GLASTAR SERVICE BULLETIN 38

MANDATORY

Subject: AN470A4-9 soft rivets

Applicability: Kits #5402, 5408, 5414, 5464, 5515, 5538, 5539, 5568, 5586, 5602, 5603, 5604 and 5610

Figure 1

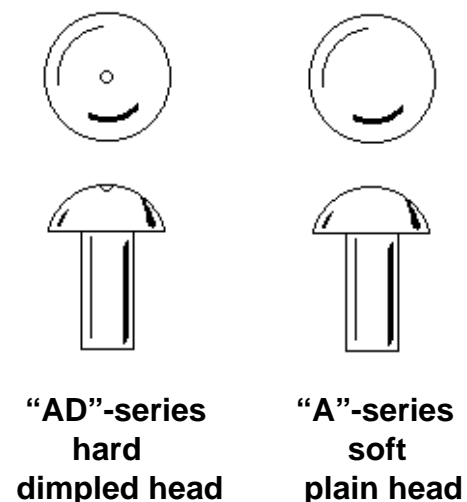
Required Action: First, inspect your supply of AN470AD4-9 rivets and remove all the soft, "A"-series rivets. They can be distinguished from the "AD"-series rivets by the heads. As shown in Figure 1, the standard, "AD"-series rivets have a small dimple in the center of the head, while the soft, "A"-series rivets have plain heads.

Second, inspect any completed work on your GlaStar wings to see if any soft, "A"-series rivets were used. In all likelihood, you would have discovered the "A"-series rivets while riveting because they are so much softer than "AD"-series rivets that they drive with a distinctly different, softer feel. If you discover any soft rivets, **you must drill them out and replace them** with proper AN470AD4-9 rivets. If necessary, refer to "SECTION II: TOOLS AND TECHNIQUES" in the *GlaStar Assembly Manual* to refresh your memory on the proper procedure for replacing defective rivets.
